V2500-A5/D5 SERIES PROPULSION SYSTEM SERVICE BULLETIN

This document transmits Revision 2 to Service Bulletin EV2500-72-0487 and Revision 2 to the Supplement

V2500-ENG-72-0487

ENGINE – HP COMPRESSOR BLADES – INTRODUCTION OF A STAGE 3 BLADE WITH A REVISED
CLAPPER – MOD 72-0487.

HP Compressor Stage 3 Rotor Blade Family Tree
Fig. 1

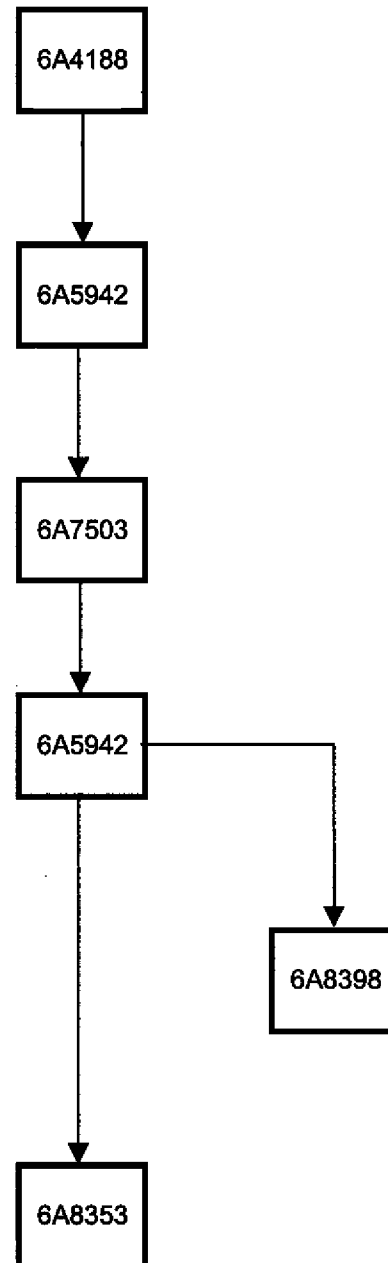
- (1) Refer to figure 1. New 6A8353 stage 3 HP compressor blades are only interchangeable as a complete set with existing stage 3 HP compressor blades.
- (2) Assemble in accordance with approved procedures, Engine Manual, 72-41-10, 72-41-00, Assembly.
